ADDENDUM NO. 1

Date: April 10, 2023

Project: Project #0410-409-1 Albert Einstein MS Re-roof

RECOVERED INTEGRAL GUTTER AT EXISTING I-BEAM

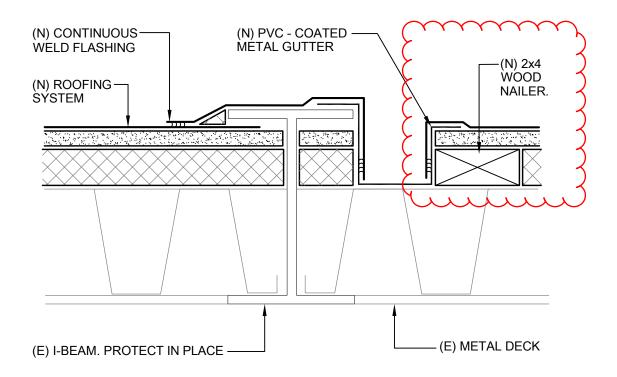
- Replace detail 18/A651 per addendum drawing number AD1.13-01. Addition of 2x4 nailer in alteration detail.
- Replace detail 19/A651 per addendum drawing number AD1.13-02. Addition of 2x4 nailer in alteration detail.
- Replace detail 20/A651 per addendum drawing number AD1.13-03. Addition of 2x4 nailer in alteration detail.
